WA/2022/01887 Land at Scotland Park, Midhurst Road, Haslemere

Further to our ongoing discussions and the completion of the Surrey County Council led Stage 1 Road Safety Audit, this letter presents our formal response (Designer's Response) to the Road Safety Audit (RSA) and provides confirmation on the remaining highway matters, including confirmation of the Applicant's willingness to agree to the financial contributions that have been requested by the Highway Authority.

**A286 MIDHURST ROAD
(NEAR D5524 SCOTLAND LANE)
HASLEMERE
PROPOSED GHOSTED RIGHT TURN LANE
JUNCTION AND SPEED MANAGEMENT
MEASURES**

**ROAD SAFETY AUDIT
STAGE 1**

Drawing Title	MIDHURST ROAD PROPOSED SPEED ROUNDELS [SHEET 8 OF 8]
Drawing Status	FOR PLANNING
Drawn	AS
Designed	SP
Date	APR 2022
Scale	1:500
Size	A3
Drawing No.	17054-024
Rev	C

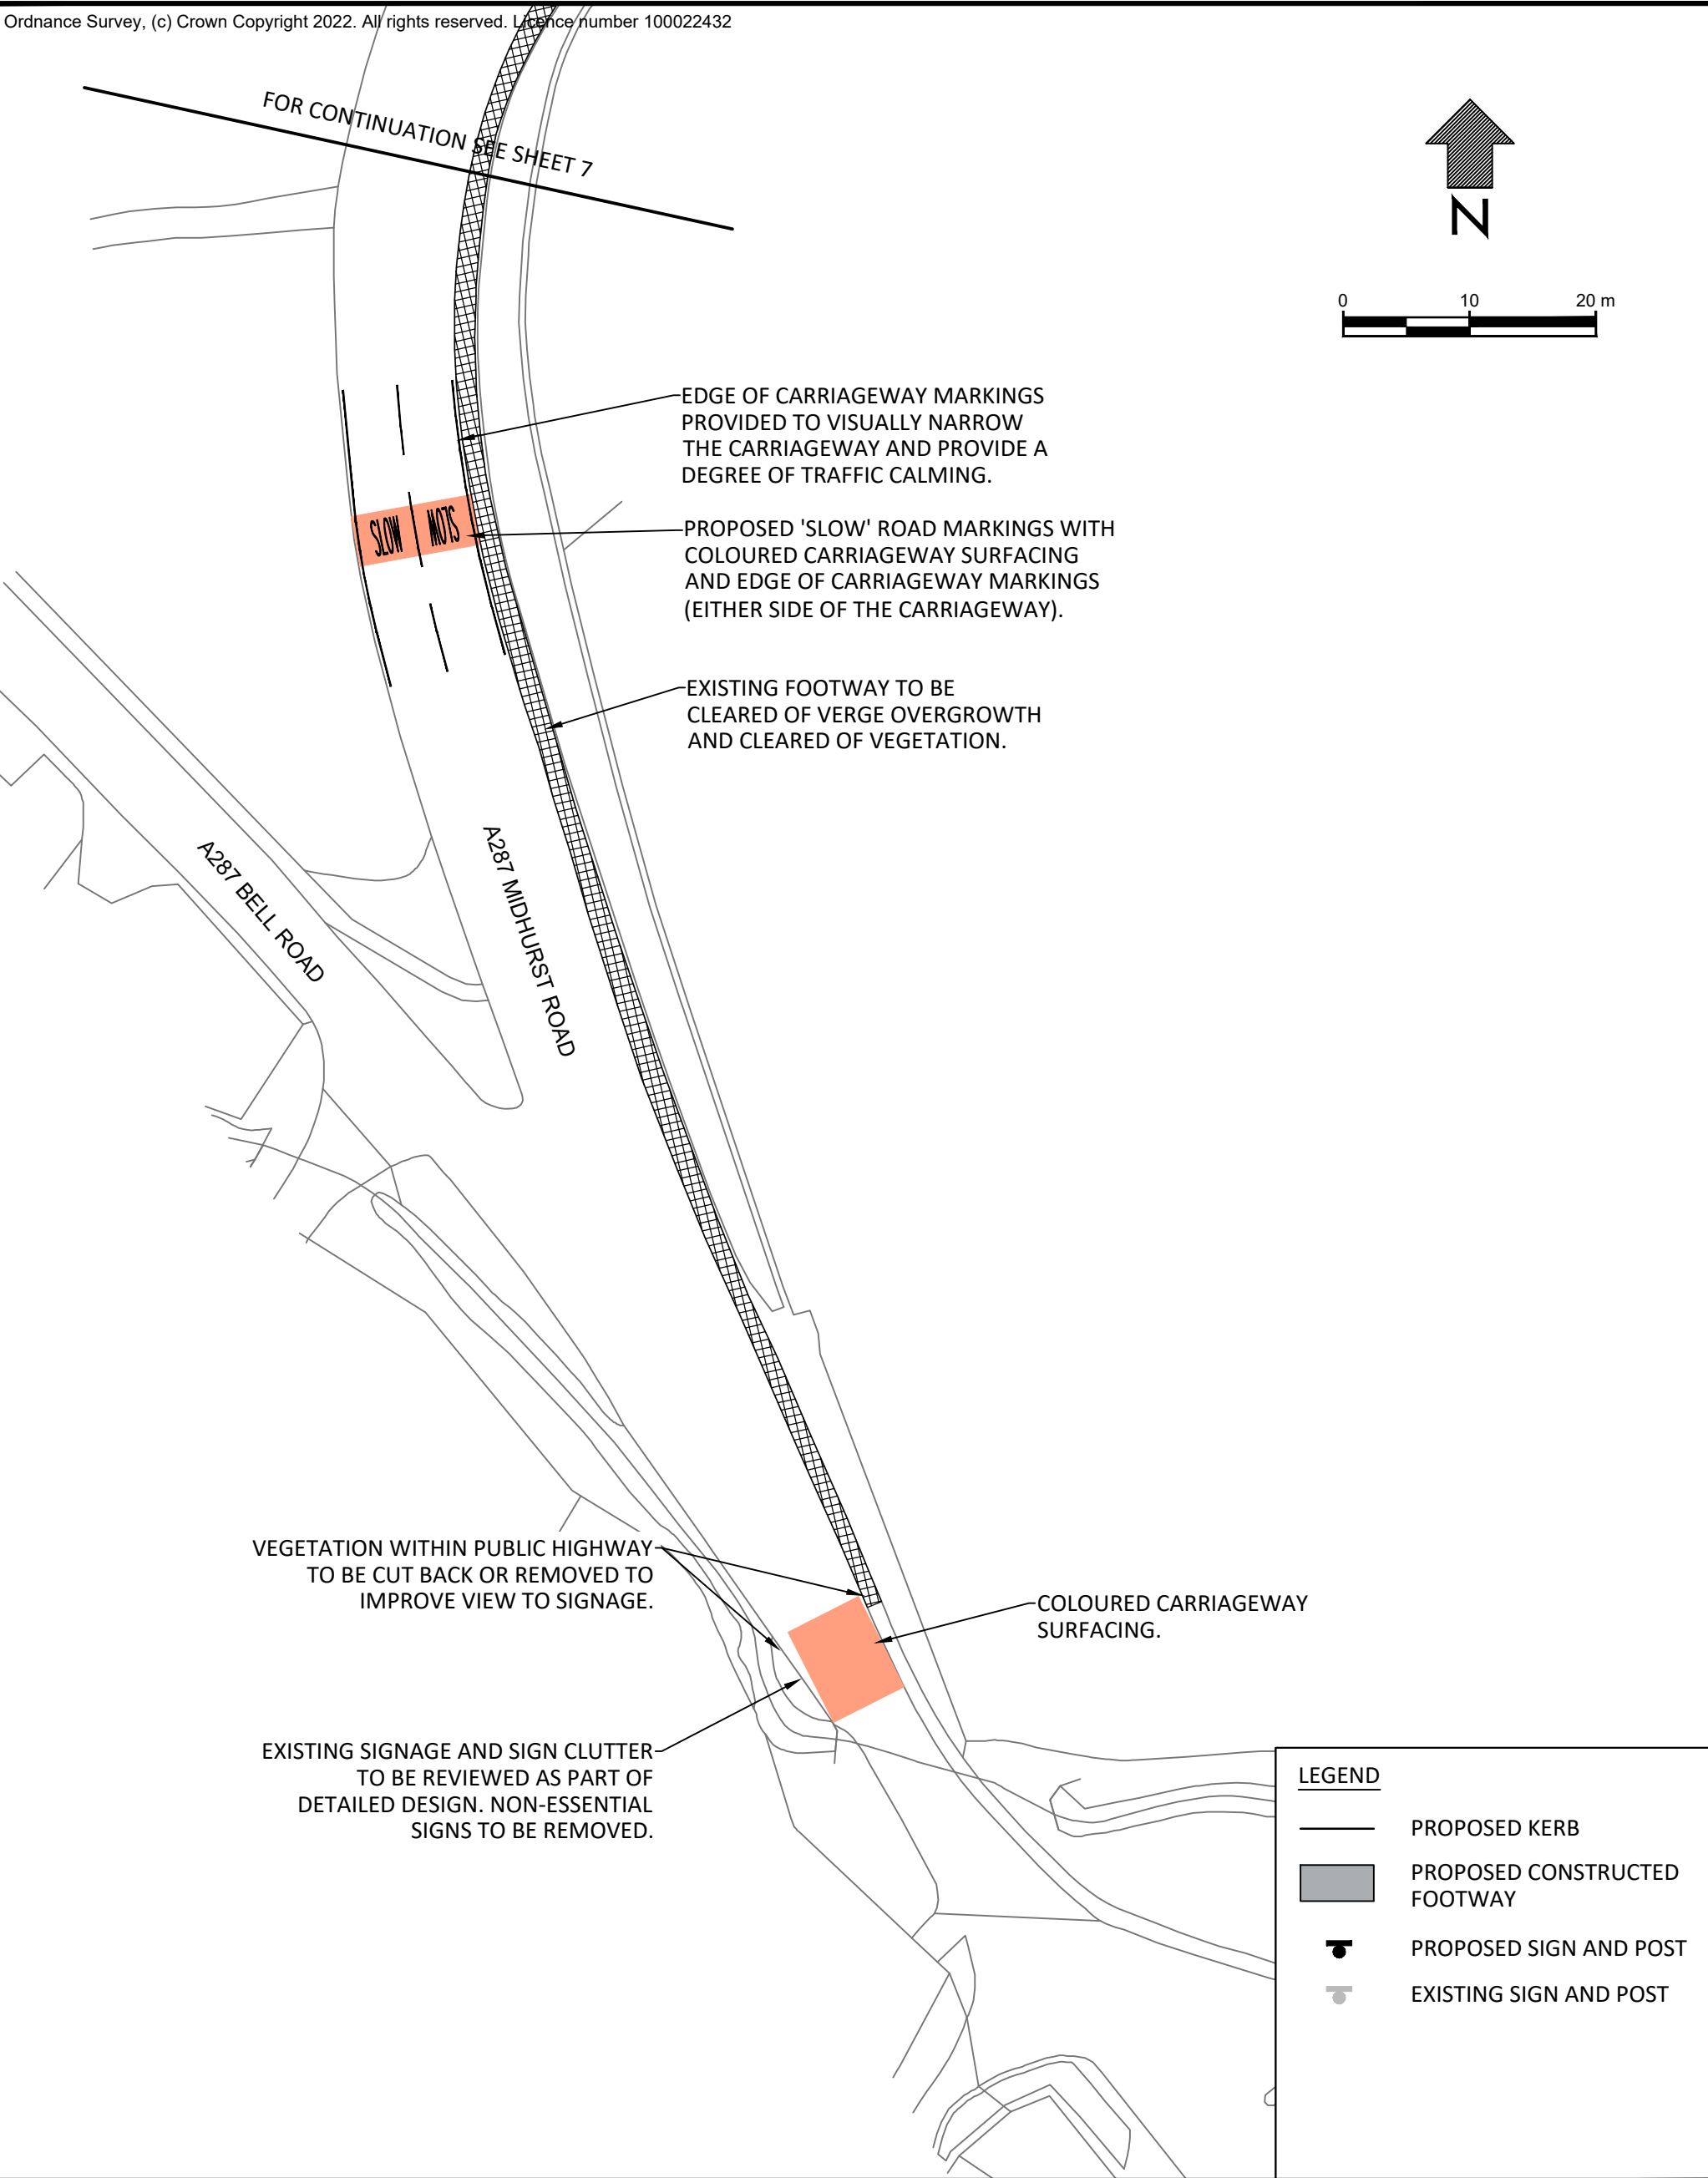
1.3 PROBLEM (Location: Appendix C-2, Dwg. No. 17054.024 Rev A, Sheet 8)

Summary: Risk of vehicle/pedestrian conflicts, due to signs obstructing footway.

The existing footway on the eastern side of A286 Midhurst Road, between the two links connecting to/from Bell Road, is narrow and flanked by vergeside shrubbery. The proposed location for back-to-back 30mph repeater sign at this point would not be seen by southbound A286 drivers due to the horizontal carriageway alignment and the sign post may cause further obstruction to the footway. Pedestrians stepping into the carriageway to avoid the overgrown and/or obstructed footway would increase the risk of vehicle/pedestrian conflicts.

the footway is cleared of verge overgrowth and trees are cut back to improve southbound driver visibility through the A286 bend, and;

the proposed 30mph repeater signs for the eastern side of the A286 are removed from the design proposals.

- Existing 40 mph speed limit now retained. Confirmation provided that the junction design (tapers and geometry etc.) is compliant with guidance having regard to the retained speed limit. Alterations to speed limit signs removed/adjusted as appropriate [Refer to Drawing 17054-024 Rev C].

- An additional length of footway is provided on the eastern side of A286 Midhurst Road, from Footpath FP37 to the existing eastern footway provision (to the south) on the eastern side of the A286 by its junction with Bell Road (N) [Refer to Drawing 17054-024 Rev C].

1.3	<p>(Location: Appendix C-2, Dwg. No. 17054.024 Rev A, Sheet 8)</p> <p>Summary: Risk of vehicle/pedestrian conflicts, due to signs obstructing footway. The existing footway on the eastern side of A286 Midhurst Road, between the two links connecting to/from Bell Road, is narrow and flanked by vergeside shrubbery. The proposed location for back-to-back 30mph repeater sign at this point would not be seen by southbound A286 drivers due to the horizontal carriageway alignment and the sign post may cause further obstruction to the footway. Pedestrians stepping into the carriageway to avoid the overgrown and/or obstructed footway would increase the risk of vehicle/pedestrian conflicts.</p>	<p>It is recommended that:</p> <ul style="list-style-type: none"> the footway is cleared of verge overgrowth and trees are cut back to improve southbound driver visibility through the A286 bend, and; the proposed 30mph repeater signs for the eastern side of the A286 are removed from the design proposals. 	<p>Footway to be cleared of overgrowth and vegetation to be removed. Drawings amended accordingly.</p> <p>30 mph repeater signs no longer form part of the design (40 mph speed limit retained).</p>
